**Dinuka McKenzie - M5 Planning Submission**

## Submission on Expansion of M5 To Planning NSW

Please accept the following submission for more design and planning of sound mitigation on the expansion of the M5 through the Georges River West Bridge residential receivers areas which have been overlooked by the Noise Mitigation Report.

### **11.2 Traffic Noise Modelling and Validation**

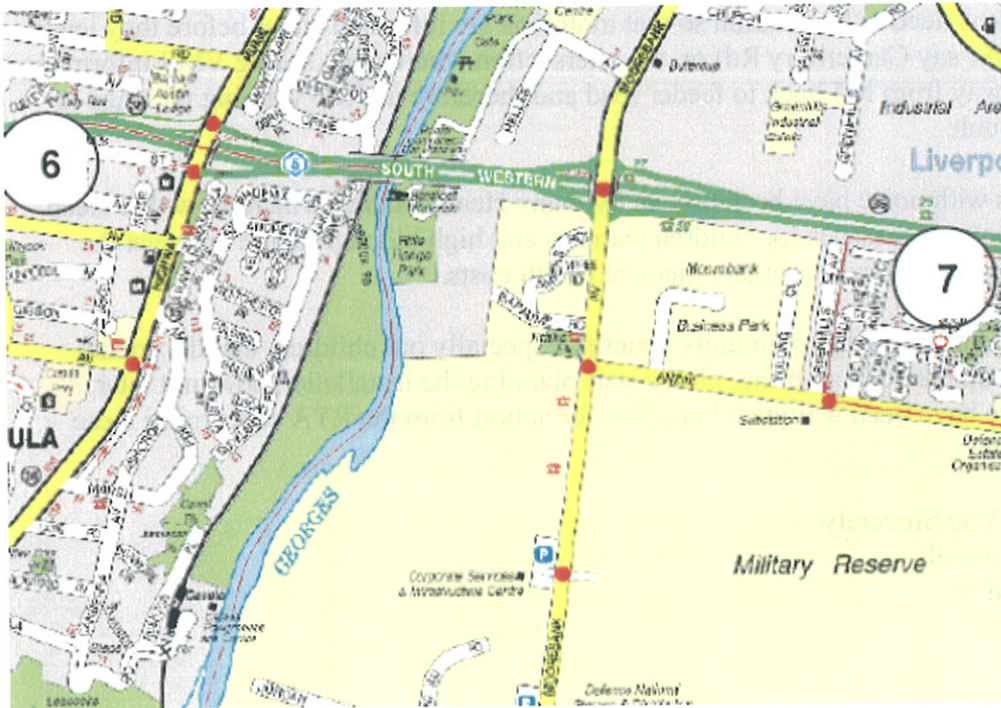
Last paragraph "Before Upgrade etc" mentions increase levels over 2db. Residents of Casula Links were advised when bridge was built that increases of this amount would qualify house to be noise mitigated along these guidelines. Has this report taken into account the increase in noise levels since inception of the M5 bridge at Casula which has affected receivers in the "Links estate". Based on these figures listed below, if not already eligible for noise mitigation, then in the very near future will be and based on the facts then it would be prudent to constructed noise mitigation now during M5 expansion works and not have to gear up to do such works when further testing is conducted in 12 months time under DGR's.

Appendix A Heggies Report 10-8495 Receivers testing location.  
 Note Receivers 6 and 7 have not addressed areas on lower residential receivers along Georges River foreshore houses and significant parklands.

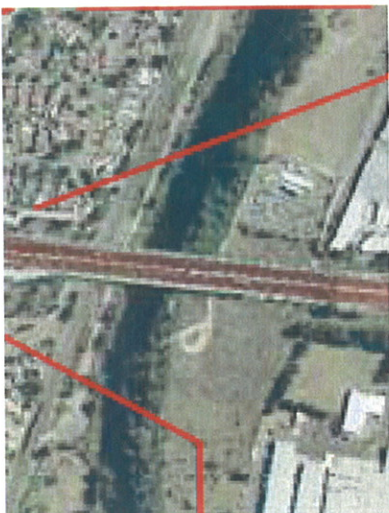
This section shows bridge section above Georges River between Moorebank Ave. and Hume Highway at Casula where no sound barriers are recommended to be installed . Please note well the houses along either side of the bridge and further along the riverbank where no sound record has been conducted..
